VSR-TSB-028

NHTSA Campaign Number: 20V-499

Vehicle Safety Recall - Technical Service Bulletin

Attention: Oshkosh Product Owner
Subject: Bendix Pressure Switch
Models Affected: Oshkosh S-Series Front Discharge Mixer
Model Year: 2020
Date: September 2020

Figure 1. Brake Treadle Valve

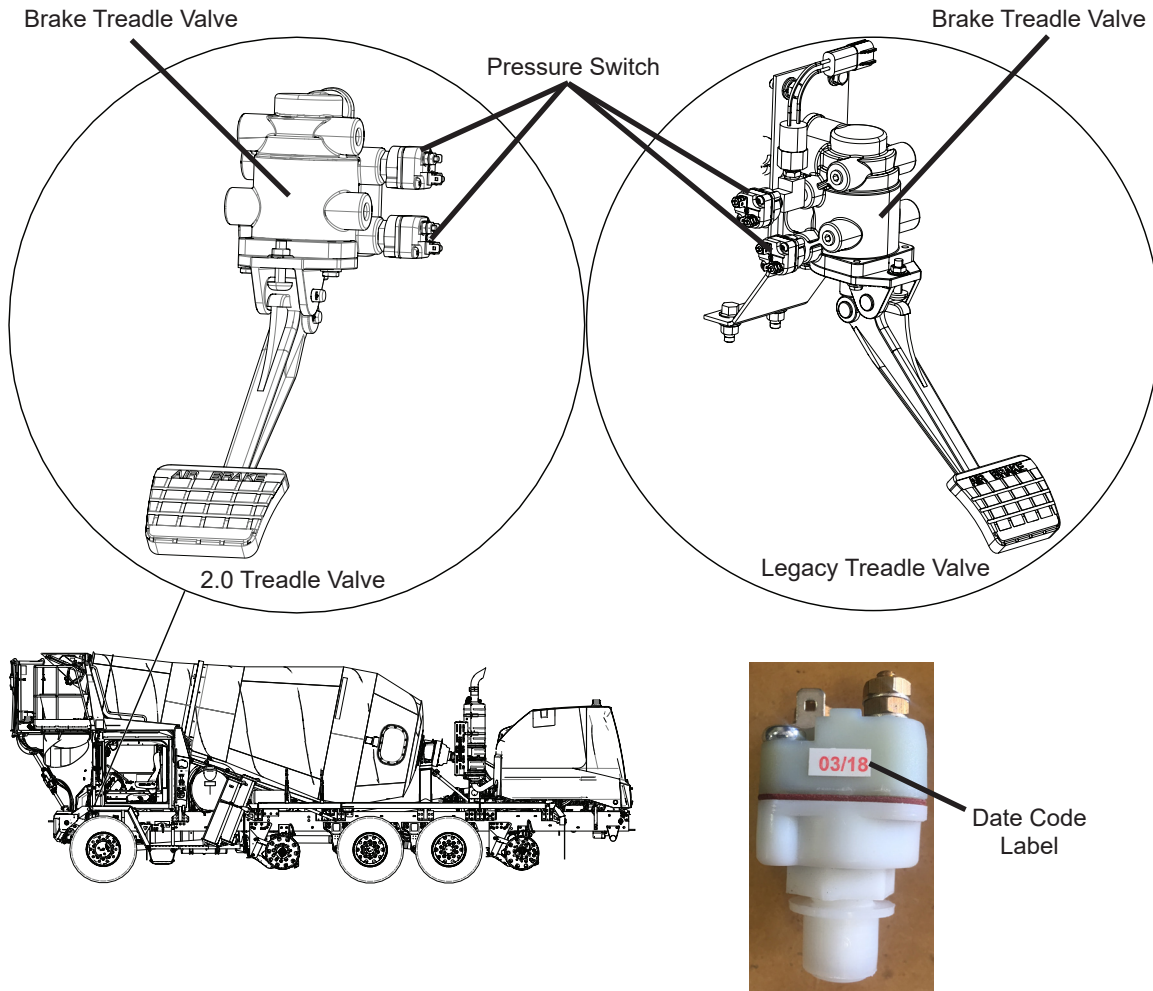
3. Locate the two Bendix pressure switches installed on the brake treadle valve, see Figure 1.
4. Check the pressure switch lot number date code label. Suspect lots include 12/19 and 01/20. See Figure 1.

- A. If either of the pressure switches lot number date code label does not include 12/19 or 01/20 this procedure is complete and no further action is required. Remove your company's Lockout/Tagout procedure. If your company does not have a Lockout/Tagout procedure, follow OSHA 1910.147 and 1910.146 Confined Space as appropriate. Remove the wheel chocks. Return the vehicle to service.
- B. If either of the pressure switches lot number date code label includes 12/19 or 01/20 **Do not run or use the vehicle**, maintain your company's Lockout/Tagout on the vehicle, and replace the pressure switch(es) per the replacement procedure.

1. Disconnect harness connections from the pressure switch.
2. Loosen and remove the pressure switch from the brake treadle valve.
3. Apply Loctite® 567 sealant to the threads of new pressure switch.
4. Install pressure switch in brake treadle valve. Final tighten pressure switch hand tight plus 2-3 turns.
5. Reconnect harness connections to pressure switch.
